Burrendong Wind Farm EIS

Application No. SSD-8950984

Submission of Objection Burrendong Save Our Surroundings

Figure 3: Burrendong Wind Farm LVIA P38 Map. Yellow markup identifies the Worlds End Ridgeline. Orange dots identify non-associated dwellings missing from impact assessments.

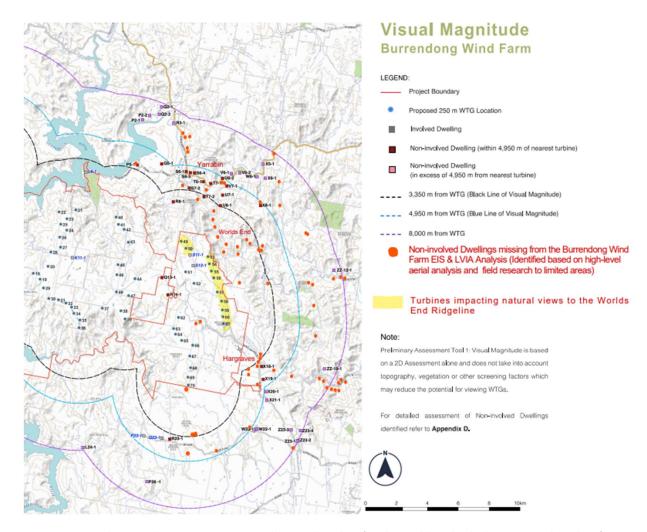
Please refer to the below map that indicates the general location of these missing non-involved dwellings (orange dots), determined by Burrendong SOS Representatives based on high-level aerial analysis, limited field research and community consultation.

As discussed earlier in this submission, over 30 dwellings have been identified as missing from the LVIA maps and visual assessments (See Figure 1 of this submission). This is a clear failure of the LVIA.

Figure 6: Proponents November 2021 Project Newsletter – Project Layout Map – Note: 10 turbines snuck onto the far east of the project site along the Worlds End Ridgeline and closest to the highest density of residents located to the north-east of the project site.

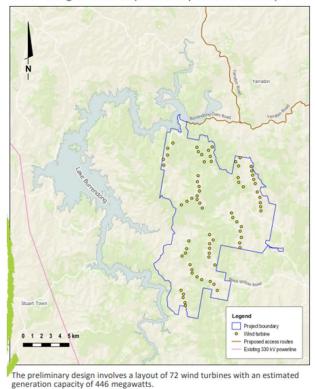
November 2021 - <u>10 turbines (Nos. 53 to 61) were subsequently snuck onto the project</u> layout map along the Worlds End Ridgeline and closest to the highest density of houses via a proponent's newsletter update dated November 2021 (viewable on the Proponents project website), without written articulation in the project update that these turbines had been added to the project.

As such, impacted landowners were not directly notified of these additional turbines that were proposed closer to their homes, nor were they afforded an opportunity to make comment into 'Visual Impact Survey' in this regard, to inform the preliminary siting and design of the project as required by the Bulletin. We note the abovementioned Visual Impact Survey had closed 10 months prior.

Figure 8 - Worlds End Ridgeline location highlighted yellow. Extracted from Pg 30 of LVIA – Figure 12: Existing Landscape Character and Key Features Map

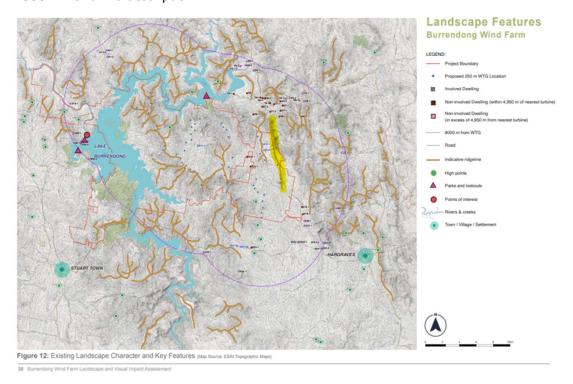
The Worlds End Ridgeline is zoned C3 Environmental Management under MWRLEP. The proposal does not meet the following objectives of this zone:

- To protect, manage and restore areas with special aesthetic values
- To provide for a limited range of development that does not have an adverse effect on those values.

Figure 10: Burrendong Wind Farm EIS – Public Viewpoint Analysis Locations, Burrendong Wind Farm (P118). Modified by identifying missing public viewpoint location.

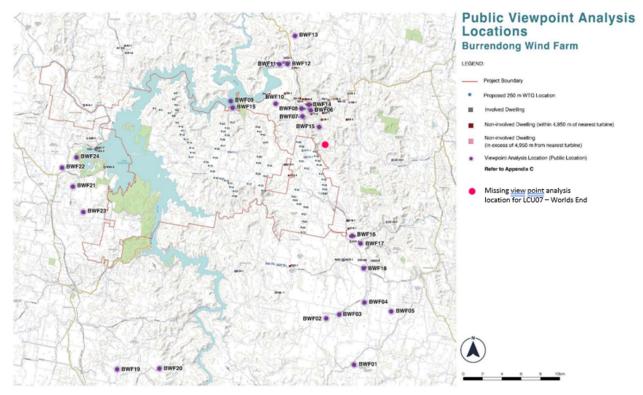
The EIS does not meet the Bulletin requirements because, it fails to identify and analyse the worst-case public viewpoint scenarios. Burrendong SOS requests that the Public Viewpoint Analysis and selected locations be independently assessed.

For example, in our opinion, the worst-case public viewpoint location for LCU07-Worlds End is marked with a pink dot on the below map - to the east of Worlds End Ridgeline and the Meroo River, and affords a High Visual Influence Zone (VIZ) rating of 1 for LCU07. Even though the proponent consultant visited the pink dot location in March 2023, it selected an alternate public viewpoint (BWF15) with a lower visual impact and assigned a low VIZ rating of 3 for LCU07- Worlds End. The description of BWF15 in the LVIA fails to identify the Worlds End Ridgeline that is highly valued by surrounding landowners and residents. This deviates from the worst case scenario analysis required by the Bulletin.

Figure 12: Dwelling U8-1, 60° Sector Multiple Wind Turbine Assessment for the Burrendong Wind Farm Proposal (LVIA Appendix D)

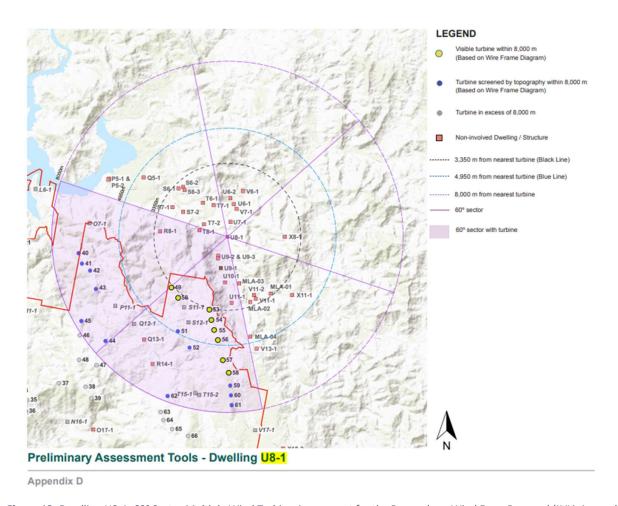
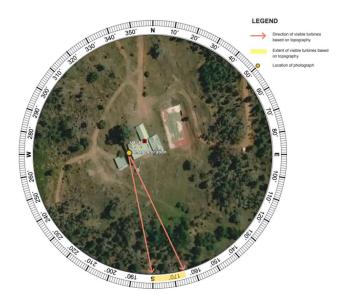
An example of the failure of the LVIA's cumulative impact assessment is illustrated below for Dwelling U8-1. The cumulative number of 60° sectors that Dwelling U8-1 will see turbines in is 3 x 60° sectors (including Piambong Wind Farm turbines) **NOT** 1-2 sectors as stated in the LVIA. The following 60° diagrams from the proposed Burrendong Wind Farm and the proposed Piambong Wind Farm prove this point.

The above image extracted from LVIA Appendix D for Dwelling U8-1 is incorrect as it fails to indicate turbine Nos. 49 and 50 that are partially visible from the dwellings primary living area and entertaining deck at 204° and 213° (as depicted in the photomontage). It also fails to incorporate the proposed Piambong Wind Farm turbines that would be visible from the dwellings northern kitchen/dining area windows (see below).
